MONTGOMERY COUNTY HISTORIC PRESERVATION COMMISSION
STAFF REPORT

Address:	2 West Melrose Street, Chevy Chase	Meeting Date:	10/27/2021
Resource:	Non-Contributing Resource (Chevy Chase Village Historic District)	Report Date:	10/20/2021
		Public Notice:	10/13/2021
Applicant:	Roman Matinez (David Easterday, Architect)	Tax Credit:	N/A
Review:	HAWP	Staff:	Michael Kyne
Permit Number:	968997

PROPOSAL: Side porch enclosure, new roof, new windows and doors, and other alterations.

Fig. 1: Subject property.

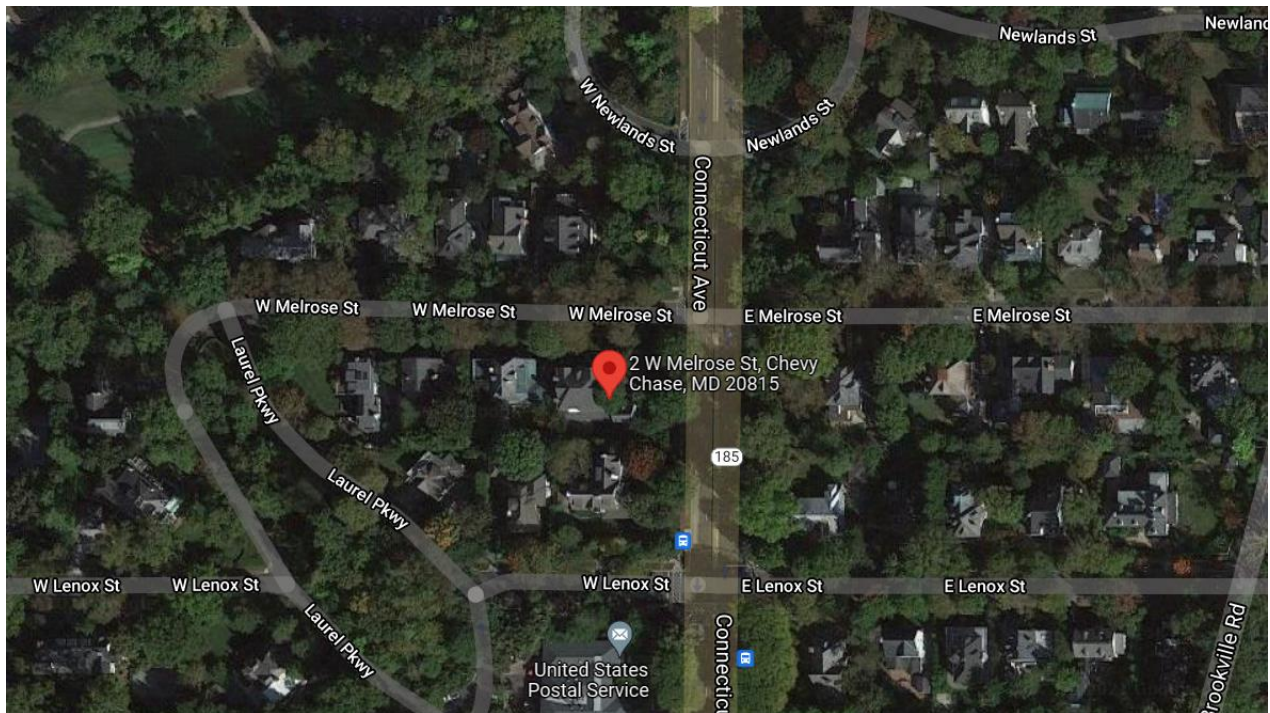
The subject property is a Non-Contributing Resource within the Chevy Chase Village Historic District. The house was constructed in 1999 and is located on the corner of West Melrose Street and Connecticut Avenue.
